Tandara Childcare Centre

Access Audit of Existing Childcare Centre

24 Jul 2018

Project reference number 18159- B

Laundry

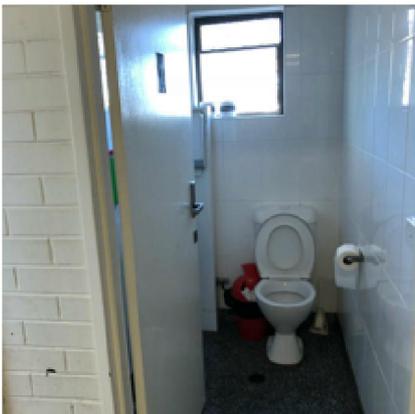
Doors to laundry are non-compliant with AS1428.1. Circulation spaces in laundry is not compliant. 1550mm circulation spaces are required in between the appliances and benchtops.

Male toilet

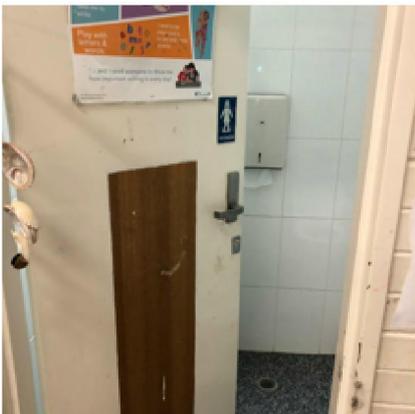
In this development since separate male and female toilets are provided, BCA requires ambulant use toilets. However given the age group of children we would not recommend this as ambulant toilet pans are higher than standard pans. We would recommend use of correct compliant signage.

Female toilet

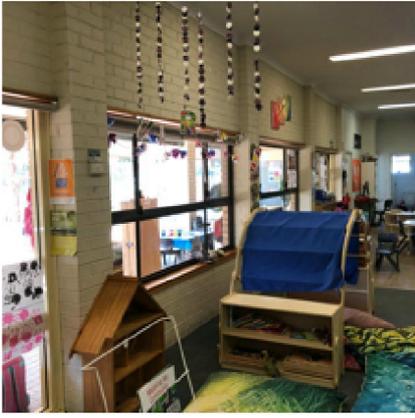
In this development since separate male and female toilets are provided, BCA requires ambulant use toilets. However given the age group of children we would not recommend this as ambulant toilet pans are higher than standard pans. We would recommend use of correct compliant signage.

External doorways to play area.

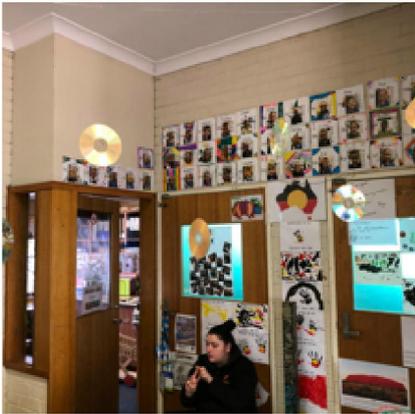
External doors have the required opening width however adequate latch side clearance is not provided due to piers in the latch side circulation spaces (not shown on architectural plans)

Kitchen and other staff area

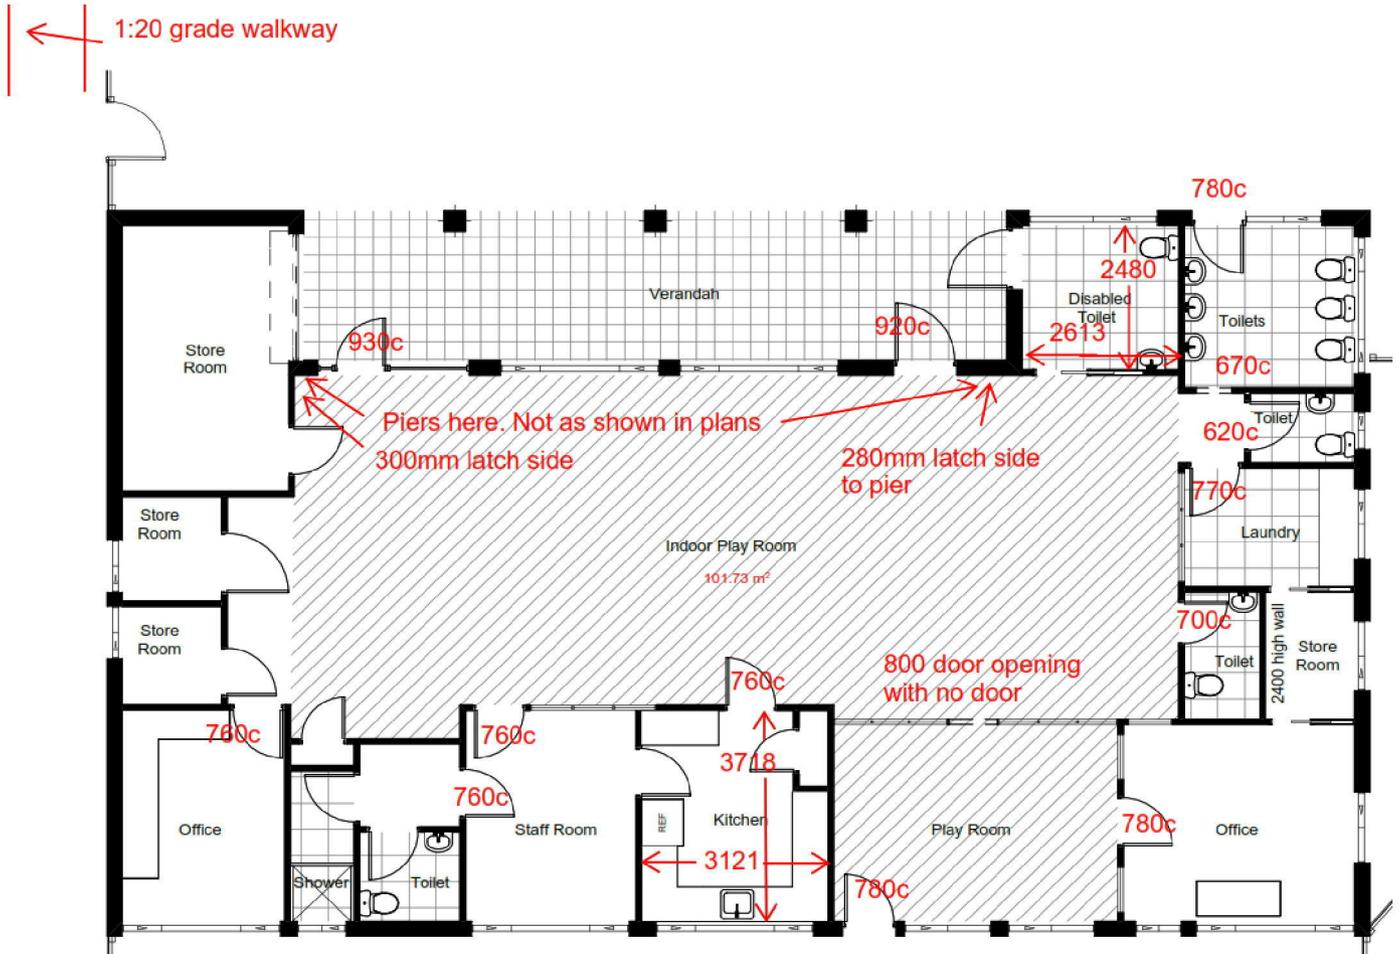
Doors to kitchen and other staff areas do not have clear door opening widths or circulation spaces as required by AS1428.1-2009.
